CITY PLANNING DEPARTMENT

Memorandum

To: City Plan Commission
From: Jonas U. Bruggemann, MSCRP | Senior Planner
Date: March 26, 2025 – **Amended March 27, 2025**
RE: 1381 Cranston Street – Assessors Plat 8, Lot 195, 1617, 2711
“**Cranston Print Works**” – Major Land Development Project: Preliminary Plan

Site Plan of Proposal

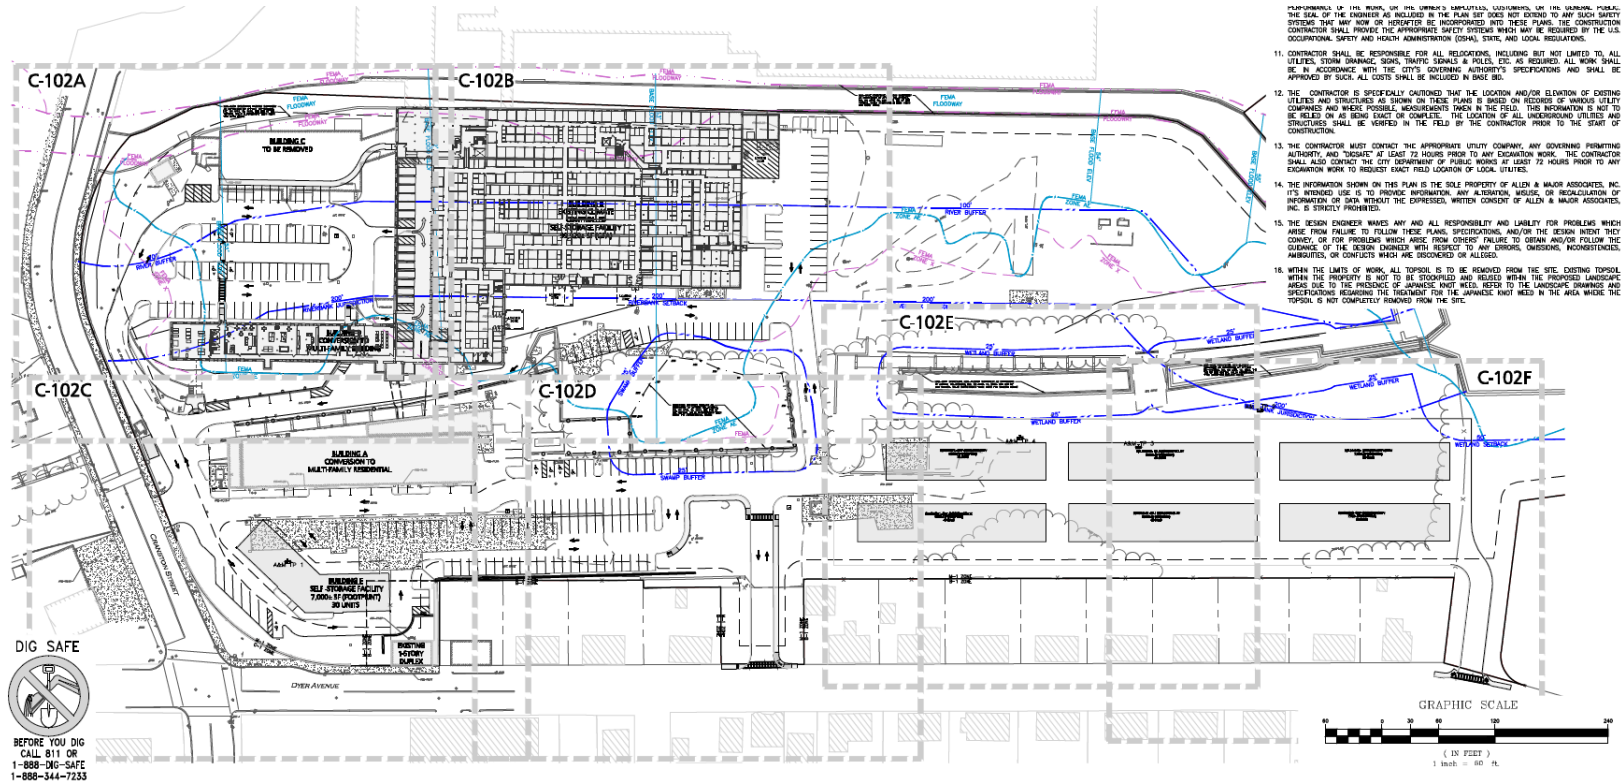
The 3-story granite building at the corner of Cranston Street and the Pocasset River identified as “Building C” on the Site Plans is to be demolished as it was deemed structurally insufficient. Instead, the building will be replaced with landscaping and a walkway between the southern parking lot and Building B. As building C was proposed to house residential units, the total number of proposed dwelling units has decreased from 129 to 100.

- Traffic associated with the development can be adequately accommodated with existing infrastructure
- The Traffic Impact and Access Study provided a list of recommendations for the project, some of which are not reflected in the Preliminary Plan, including:

- Driveways should have STOP-signs and painted STOP-bars
 - Landscaping adjacent to the project site driveways should be designed and maintained so as not to restrict lines of site.

- The Traffic Impact and Access Study also discussed that the proposal includes indoor and outdoor parking for bicycles.
 - While indoor bicycle storage has been included Outdoor bicycle parking has not been included on the site plan.

- Staff recommend that inclusion of outdoor bicycle racks, adjustments to landscaping, and the addition of STOP-signs are conditioned as part of the approval.

- Trees proposed along Dyer Avenue may interfere with overhead powerlines. In particular the red maples proposed at the southeastern corner of the property and the southern driveway on Dyer Avenue. The pin oak and Armstrong maples at the Cranston Street and Dyer Ave intersection may also interfere with overhead powerlines. The majority of these trees are proposed to be planted within 20 feet of the powerline.

- Staff recommend moving the red maple species backwards or replacing them with a low-growing tree species that is compatible with overhead wires.
